AMENDMENTS TO THE DRAWINGS

Fig. 4b

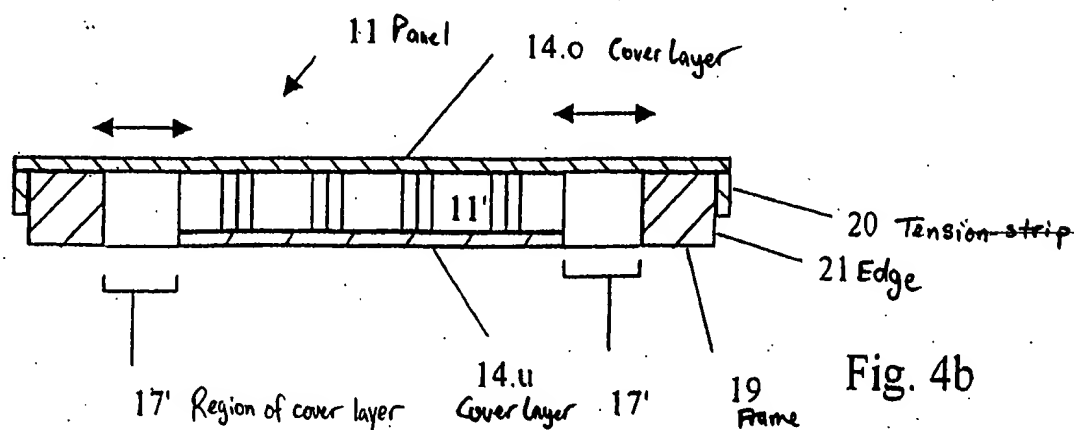
Figs. 4b and 5b are amended to indicate that reference number 17' refers to "Region of cover layer" rather than to "connecting element." Support for this amendment may be found, among other places, at page 8, line 11 and line 24 of the specification as filed.
